**Subject: Responses to Comments on the Draft Nevada 2016-2018 Integrated Report**

The Nevada Division of Environmental Protection (NDEP) Bureau of Water Quality Planning (BWQP) received comments made by the Colorado River Commission of Nevada (CRCNV) on the Draft Nevada 2016-2018 Water Quality Integrated Report. BWQP is committed to improving the accuracy of the Water Quality Integrated Report and appreciates your careful review.

Figure 1. Turbidity data used in assessment of NAC 445A.2174 for the Nevada 2016-2018 Water Quality Integrated Report, with standard of 50 NTU shown.

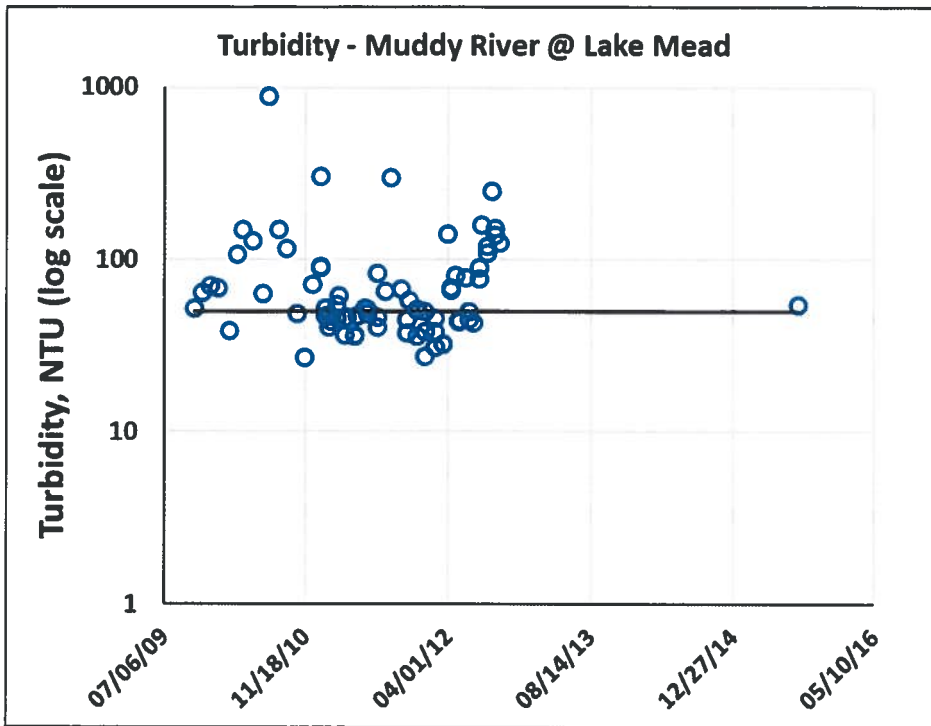
**CRCNV Comment:** Turbidity at the inflow of the Muddy River at Lake Mead.

Third, please consider removing the turbidity listing for the inflow of the Muddy River at Lake Mead. NAC 445A.2152 Colorado Region: Lake Mead states in the footnotes "The Commission recognizes that at entrances of tributaries to Lake Mead, localized violations of standards may occur." In previous meetings with NDEP CRCNV's staff have been told that this applies to turbidity in the inflow areas of Lake Mead.

BWQP Response. BWQP acknowledges the language in NAC 445A.2152 stating, "*The Commission recognizes that at entrances of tributaries to Lake Mead, localized violations of standards may occur*". This statement applies to Lake Mead where tributaries may influence the lake in their immediate mixing zone. This statement does not apply to the tributaries themselves, nor does it suggest that assessment results be disregarded when they show impairment of the standard. Data assessed for the waterbody described in NAC 445A.2174 (Muddy River at Lake Mead) show turbidity consistently greater than the standard of 50 NTU over time. After careful review of the data from six sampling sites, including 75 measurements of turbidity, from the Wells Siding Diversion to the river mouth at Lake Mead it was determined that removal of the listing for turbidity was not deemed appropriate for the Muddy River (Figure 1).
